Number: FS-2012-05

Subject: Exhaust System Flex Pipe Change

FIELD SERVICE BULLETIN

For replacement of Red Silicone (Linkeo) exhaust bellows with All Metal (Tru-Flex) exhaust bellows on 2010 Emissions year engine equipped buses

FIGURE 1. ISB DIESEL HYBRID ENGINE

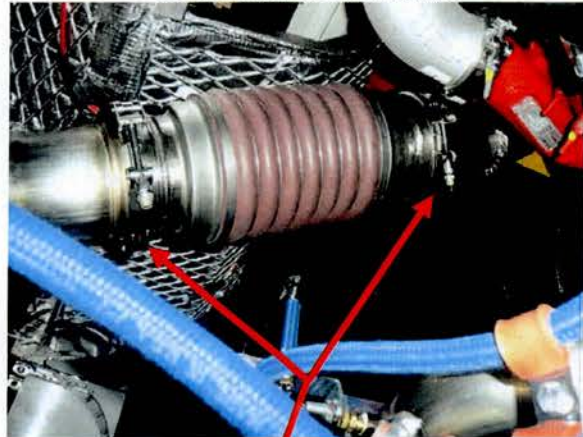
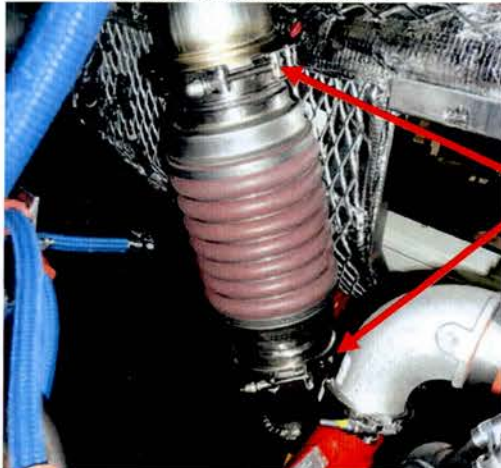
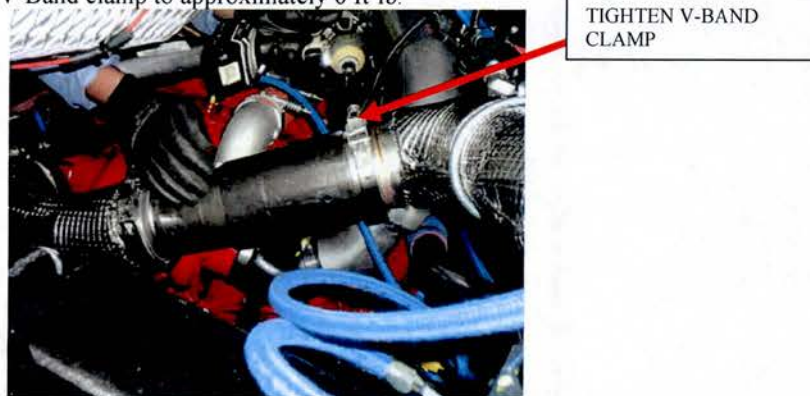
1. Remove the existing red silicone exhaust bellows from the bus by loosening the two V-Band clamps.

LOOSEN V-BAND CLAMPS
SHOWN TO REMOVE THE
EXISTING BELLOWS
(CLAMP LOCATION "C")

FIGURE 7.

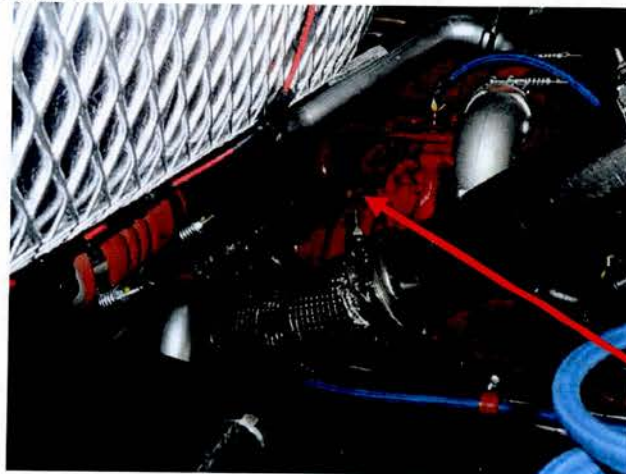
4. To access the turbo outlet pipe V-Band clamps, remove the settee hatch from inside the bus.
5. Loosen both Cummins cast turbo outlet elbow V-Band clamp and exhaust turbo outlet pipe V-Band clamp through the settee hatch access.

FIGURE 14. ISB/ISL DIESEL ENGINE SHOWN

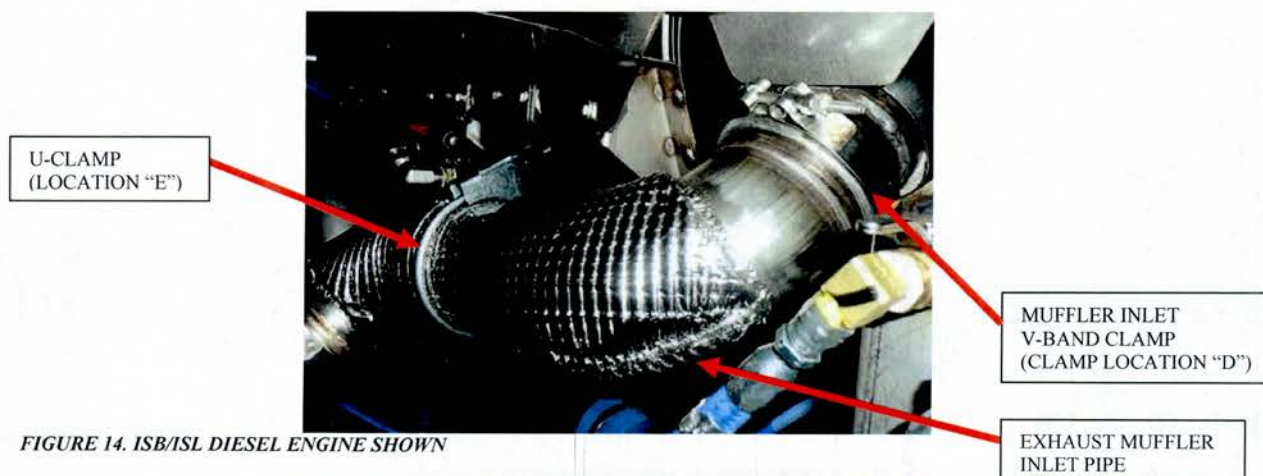
6. Loosen the V-Band & U clamps on exhaust muffler inlet pipe. Loosening the clamps will allow the pipes to move into alignment.

7. Align the pipes with alignment tool & torque all clamps to 13+/- 0.5 ft-lb in the following order:

- CAST TURBO OUTLET ELBOW V-BAND CLAMP *LOCATION "A", SEE FIGURES:
8 & 9 FOR ISB on page 4
10 & 11 FOR ISL on page 4
12 & 13 FOR ISL-G on page 5*
- EXHAUST TURBO OUTLET PIPE V-BAND CLAMP *LOCATION "B", SEE FIGURES:
8 & 9 FOR ISB on page 4
10 & 11 FOR ISL on page 4
N/A for ISL-G*
- ALIGNMENT TOOL UPPER & LOWER V-BAND CLAMPS *LOCATION "C", SEE FIGURE 16 BELOW*
- MUFFLER INLET PIPE V-BAND CLAMP *LOCATION "D", SEE FIGURES:
14 FOR ISB on page 5
14 FOR ISL on page 5
15 FOR ISL-G on page 5*
- MUFFLER INLET PIPE U-CLAMP *LOCATION "E", SEE FIGURES:
14 FOR ISB on page 5
14 FOR ISL on page 5
15 FOR ISL-G on page 5*
